ADA ACCESSIBILITY REPORT

The Fauquier County Board of Supervisors

Fauquier County, Virginia

SAMAHA ASSOCIATES, P.C.

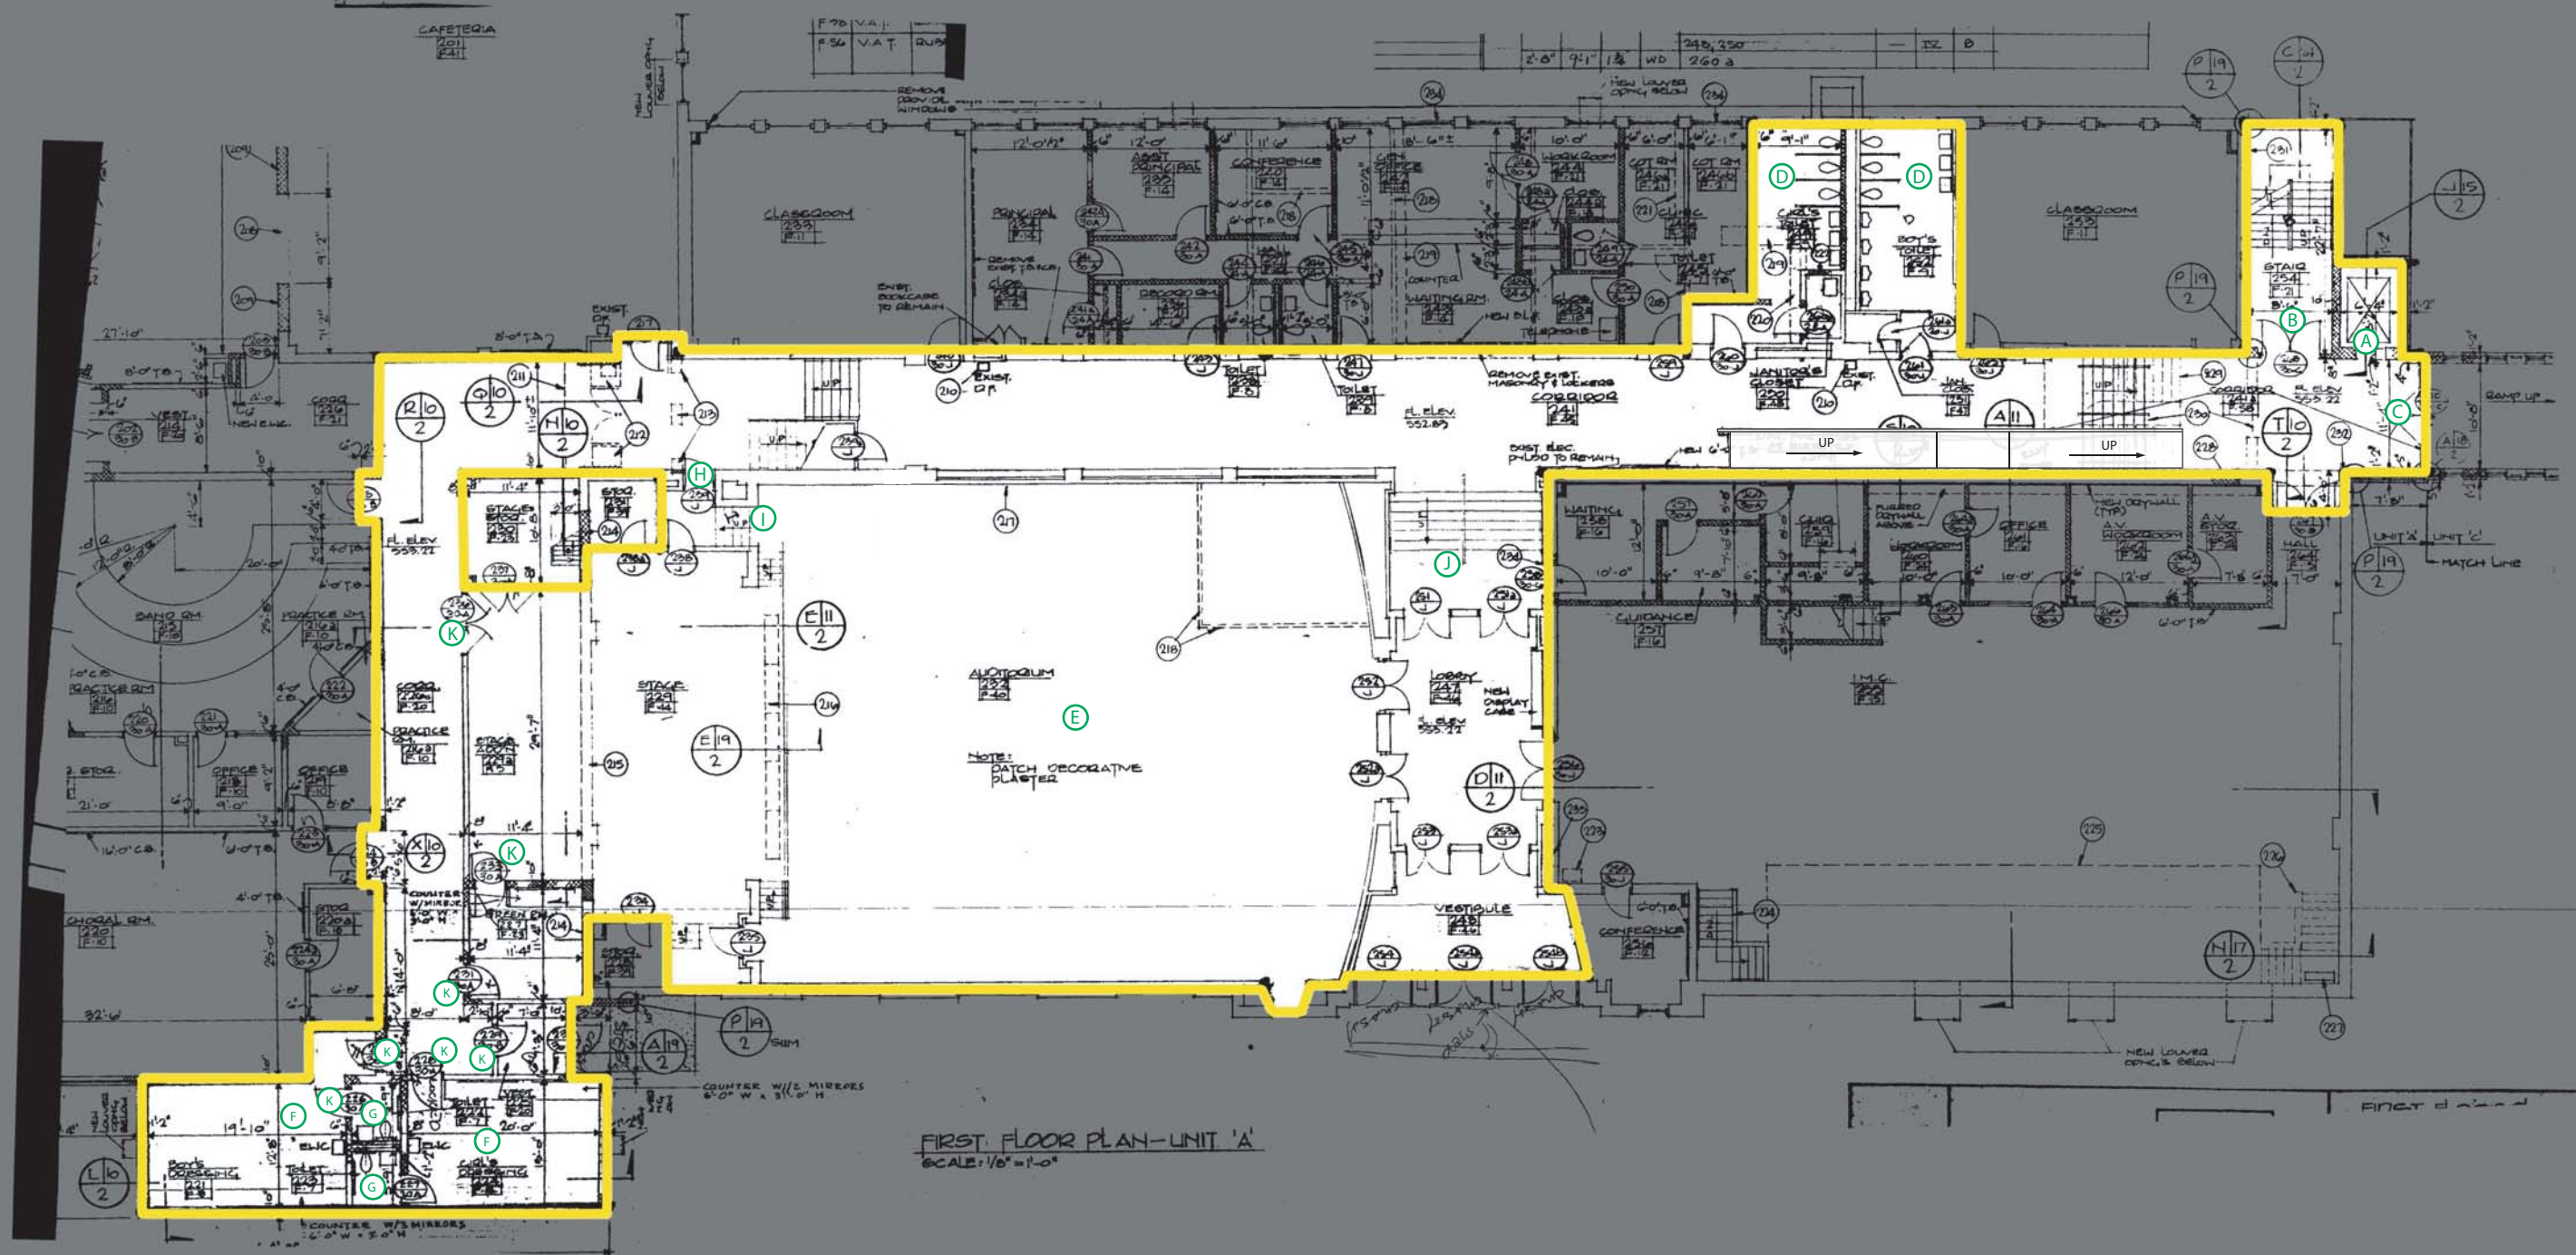
| Plan Symbol | Item | ADAAG Reference | ANSI- A117.1- 2003 Reference | Requirement | Required Effort to Comply with the ADA | Budget Estimate |
|----------------|---|--|---------------------------------------|--|--|-----------------|
| A | Keyed Operated Elevator Call System | | 407.2.1 | Where elevator call buttons or keypads are provided, they shall comply with Sections 407.2.1 and 309.4 Call buttons shall have visible signals to indicate when each call is registered and when each call is answered. | Replace call button system at both levels. | \$ 2,500.00 |
| B | Omitted Handrail | 4.9.4 | 505.2 | Required at both sides of all stairs. Location: Handrails shall be provided on both sides of stairs and ramps. | Provide new required handrails | \$ 4,000.00 |
| C | Pinch Operated Hardware at Entrance | 4.13.8 | 309.4 | Handles, pulls, latches, locks, and other operating devices shall have a shape that is easy to grasp with one hand and does not require tight graping, tight pinching, or twisting of the wrist to operate. Operation: Operable parts shall be operable withone hand and shall not require tight grasping, pinching, or twisting of the wrist. | Replace crash bar exit devices with push pad type panic hardware with lever hardware on the opposite side. (2) doors | \$ 1,000.00 |
| D | Non-Accessible Toilet Rooms | 4.1.3 | | If toilet rooms are provided, then each public or common use toilet room shall comply with this section. Exception at Existing Conditions: Where it is technically infeasible to comply with this section, the installation of at least one unisex toilet/bathroom per floor, located in the same area as existing toilet facilities, will be provided in lieu of modifying existing toilet facilities. | Renovate restrooms to provide accessibility or provide separate immediately adjacent ADA accessible toilet rooms in addition to existing restrooms. Boys and Girls Restrooms | \$ 45,000.00 |

| E | Inaccessible Stage | 4.33.5 | | An accessible route shall connect wheelchair seating locations with performing areas, including stages, arena floors, dressing rooms, locker rooms, and other spaces used by performers. | Provide an accessible wheelchair lift or ramp to access the stage. | \$ 10,000.00 |
| F | 8" Riser Height at Balcony Seating | | 504.2 | Risers shall be 4" minimum and 7" maximum in height. | Provide intermediate risers | \$ 4,000.00 |
| G | No Accessible Portion of Counter | 7.2 | 904.3.2 | A portion of the main counter, minimum 36" in length, maximum of 36" above the floor, shall be provided. Forward Approach: A portion of the counter surface 30" min. in length and 36" max. in height above the floor shall be provided. A clear space complying with section 305, positioned for a forward approach to the accessible counter shall be provided. Knee and toe clearance complying with Section 306 shall be provided under the accessible counter. | Replace portion of counter at (2) locations | \$ 2,000.00 |

| H | Inaccessible Maneuvering Clearances at Doorway | 4.13.6 | Table 404.2.3.1 | Front approach to pull side: 18" beyond latch side of door, 60" perpendicular to doorway. Maneuvering Clearances at Manual Swing Doors: For front approach from pull side, 18" parallel to doorway beyond latch side of door, 60" perpendicular to doorway. | Relocate interior partitions and replace door and frame to accommodate required clearances. | \$ 4,000.00 |
| I | Omitted Handrails | 4.9.4 | 505.2 | Required at both sides of all stairs. Location: Handrails shall be provided on both sides of stairs and ramps. | Provide new required handrails | \$ 1,000.00 |
| J | 27" Handrail Height | 4.9.4(5) | 505.4 | Height: 34" - 38", measured from stair nosing. Height: Top of gripping surfaces of handrails shall be 34" min. and 38" max. vertically above stair noisings, ramp surfaces and walking surfaces. | Provide new required handrails | \$ 2,500.00 |
| K | Knob Hardware | 4.13.8 | 309.4 | Handles, pulls, latches, locks, and other operating devices shall have a shape that is easy to grasp with one hand and does not require tight graping, tight pinching, or twisting of the wrist to operate. Operation: Operable parts shall be operable withone hand and shall not require tight grasping, pinching, or twisting of the wrist. | Replace knob hardware with levers at approximately 8 locations | \$ 500.00 |

MAIN BUILDING - 1st FLOOR PLAN
Scale: 1/8" = 1'-0"

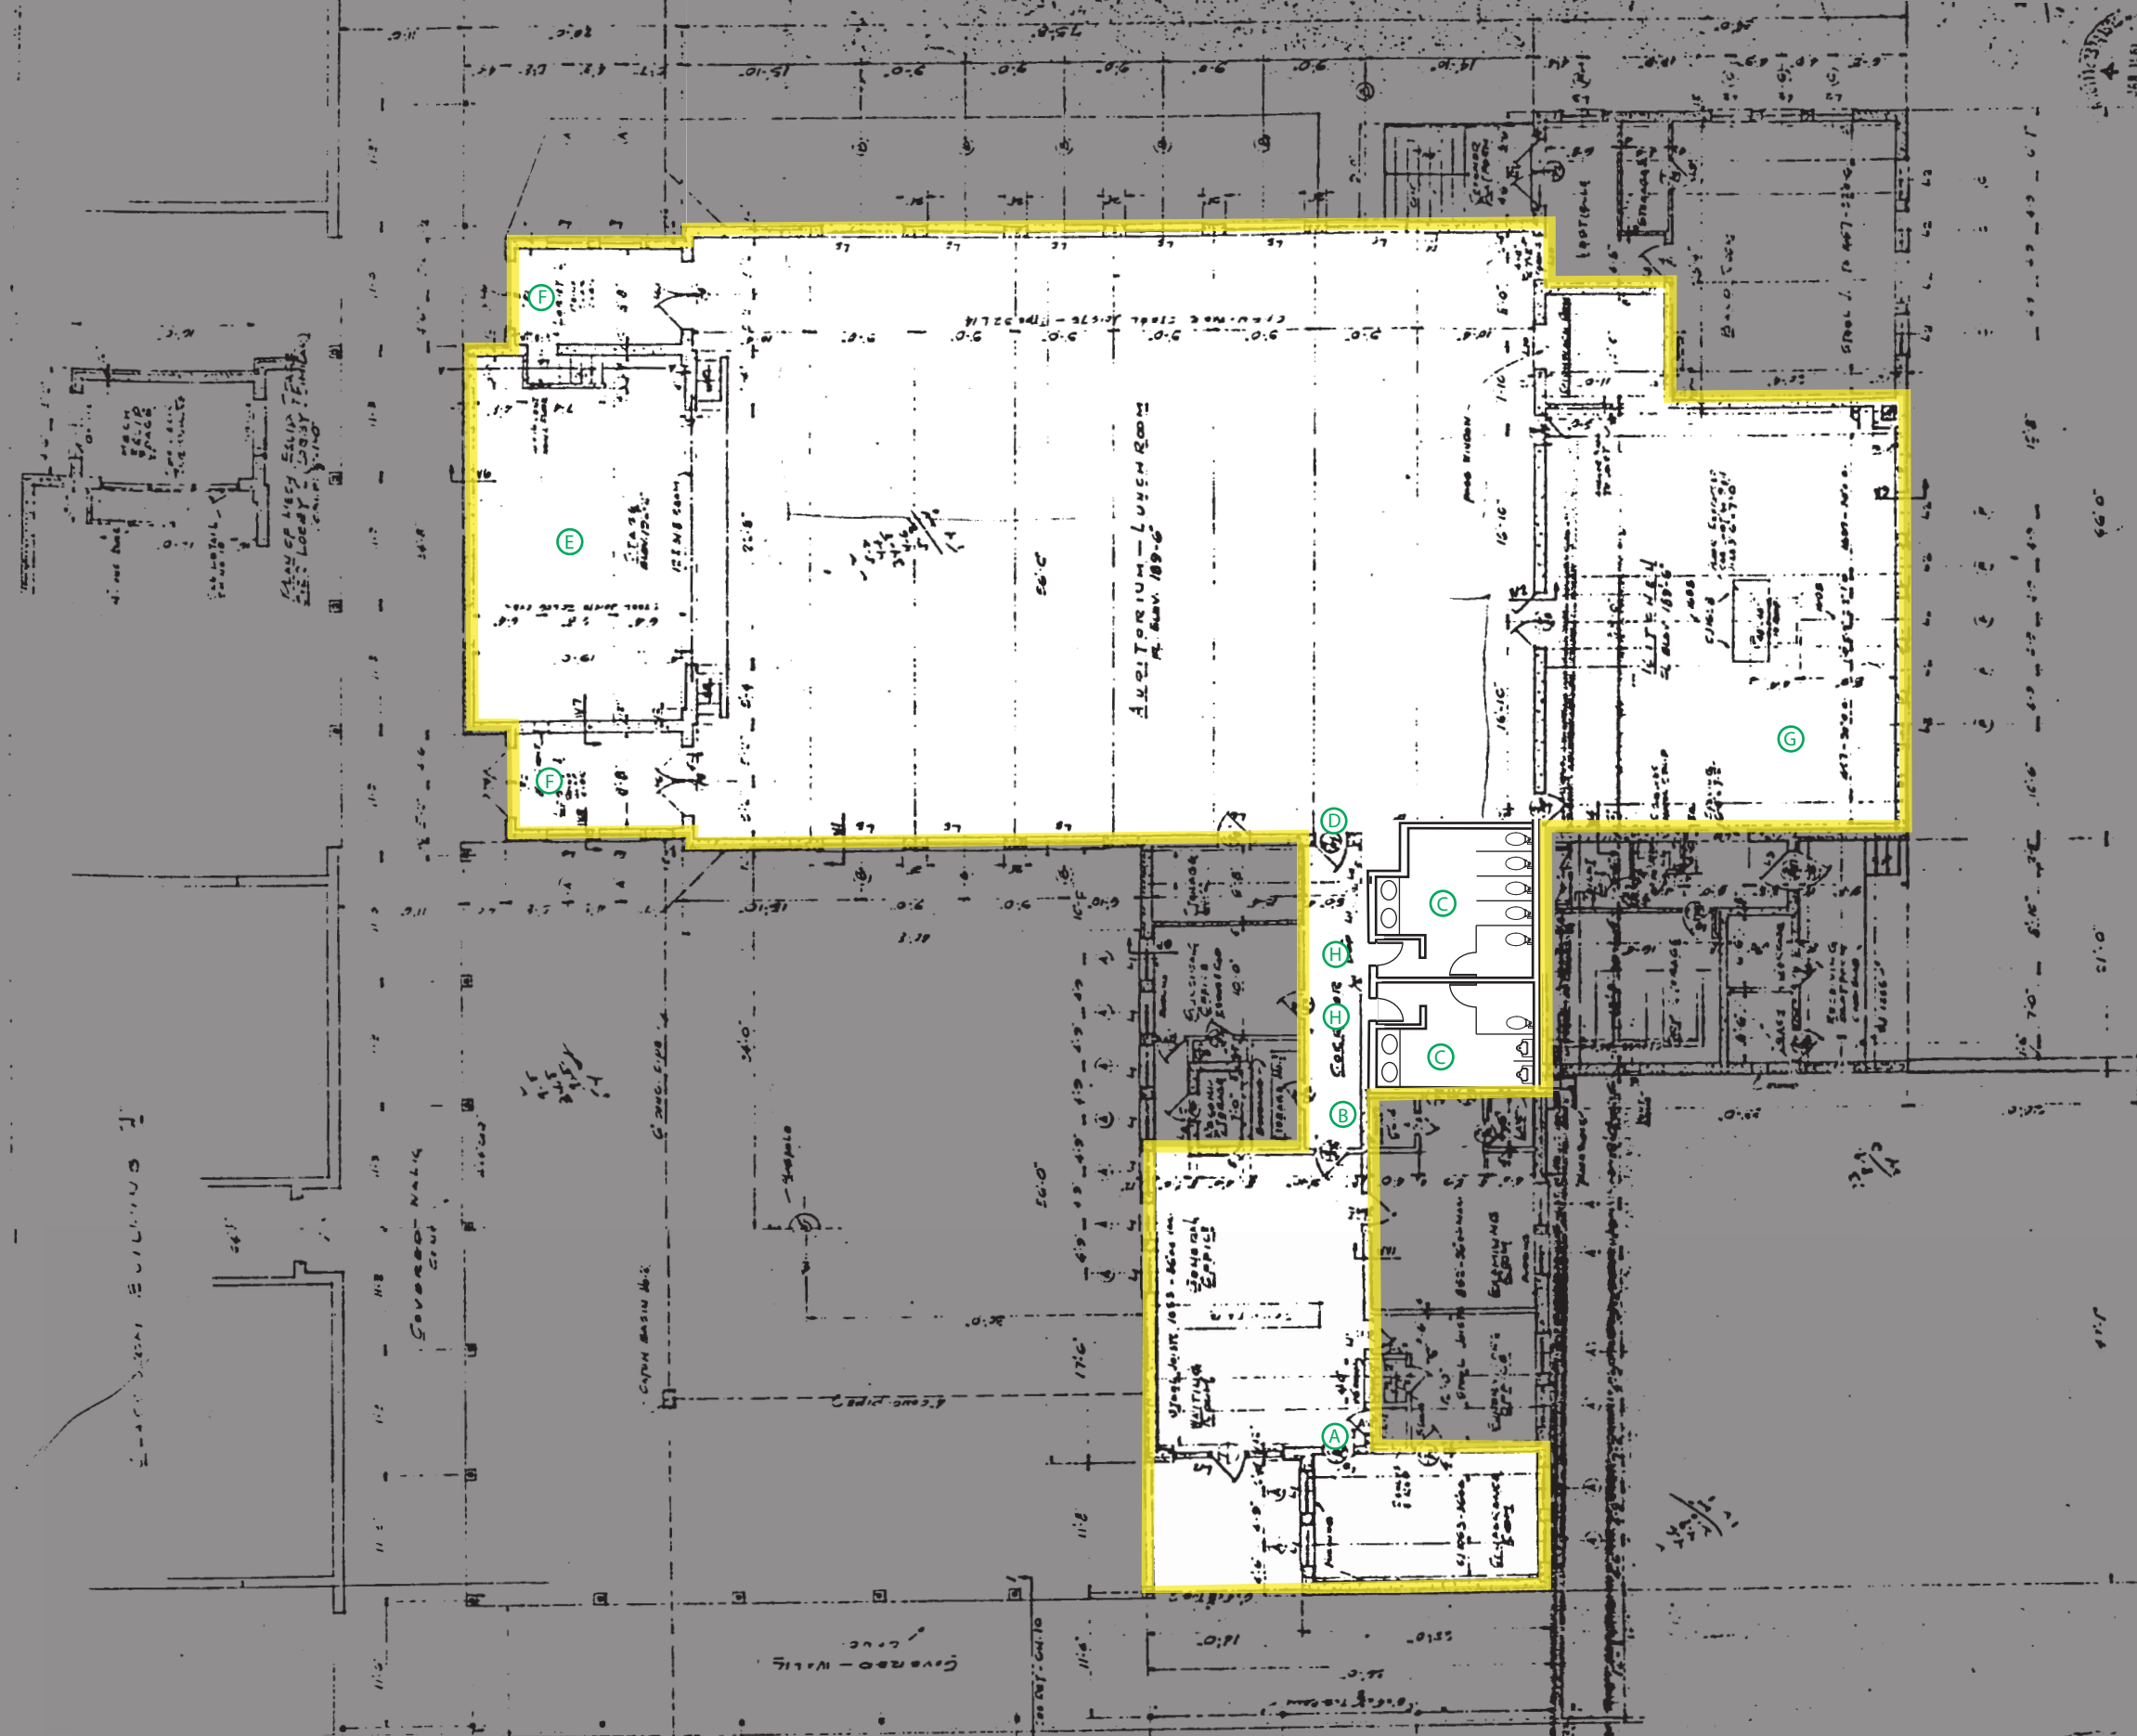
| Plan Symbol | Item | ADAAG Reference | ANSI- A117.1- 2003 Reference | Requirement | Required Effort to Comply with the ADA | Budget Estimate |
|-------------------|--|--------------------|---------------------------------------|---|--|-----------------|
| A | 9" Manuvering Clearance at Pull Side of Door | 4.13.6 | Table 404.2.3.1 | Front approach to pull side: 18" beyond latch side of door, 60" perpendicular to doorway. Maneuving Clearances at Manual Swing Doors: For front approach from pull side, 18" parallel to doorway beyond latch side of door, 60" perpendicular to doorway. | Relocate interior partitions and replace door and frame to accommodate required clearances. | \$ 4,000.00 |
| B | Life Pak & Telephone | 4.4.1 | 307.2 | Protruding Objects. Objects projecting from walls with their leading edges between 27" & 80" above the finished floor shall protrude no more than 4" into walks, halls, corridors passageways or aisles. Protusion Limits: Objects with leading edges more than 27" and not more than 80" above the floor shall protrude 4" max. horizontally into the circulation path. | Recess Life Pak Equipment and relocated telephone out of corridor or provide vertical extension to a height of 27" or less. | \$ 2,000.00 |
| C | 36" Perp. to HDCP. Stall Doorway | 4.17.5 | 604.9.3 | Doors: Toilet stall doors, including harware, shall comply with Element 10: Doors Exception: If toilet stall approach is from the latch side of the stall door, clearance between the door side of the stall and any obstruction shall be 42" min. Doors: Toilet compartment doors, including door hardware, shall comply with Section 404, except if the approach is to the latch side of the compartment door the clearance between the door side of the compartment and any obstruction shall be 42" min. | Remove portion of visual screen wall to accommodate required clearances. (2) locations | \$ 2,000.00 |
| D | 9" Manuvering Clearance at Pull Side of Door | 4.13.6 | Table 404.2.3.1 | Front approach to pull side: 18" beyond latch side of door, 60" perpendicular to doorway. Maneuving Clearances at Manual Swing Doors: For front approach from pull side, 18" parallel to doorway beyond latch side of door, 60" perpendicular to doorway. | Relocate interior partitions and replace door and frame to accommodate required clearances. | \$ 4,000.00 |
| E | Inaccessible Stage | 4.33.5 | | An accessible route shall connect wheelchair seating locations with performing areas, including stages, arena floors, dressing rooms, locker rooms, and other spaces used by performers. | Provide an accessible wheelchair lift or ramp to access the stage. | \$ 10,000.00 |
| F | Crash Bar Exit Devices Protusion at Doorway | 4.4.1 | 307.2 | Protruding Objects. Objects projecting from walls with their leading edges between 27" & 80" above the finished floor shall protrude no more than 4" into walks, halls, corridors passageways or aisles. Protusion Limits: Objects with leading edges more than 27" and not more than 80" above the floor shall protrude 4" max. horizontally into the circulation path. | Replace crash bar exit devices with push pad type panic hardware. (4) doors. | \$ 2,000.00 |
| G | Inaccessible Sink | 4.24.1 | | If sinks are provided, then at least one shall comply with this section. | Convert sink base cabinet and replace sink to allow knee clearance and forward approach. | \$ 2,000.00 |
| H | Signage Mounted to Face of Swinging Door | 4.30.6 | 703.3.11 | Where permanent identification is provided for rooms and spaces, signs shall be instilled on the wall adjacent to the latch side of the door. Location: Where a tactile sign is provided at a door, the sign shall be alongside the door at the latch side. | Relocate interior signage per code requirements. (2) locations | \$ 100.00 |
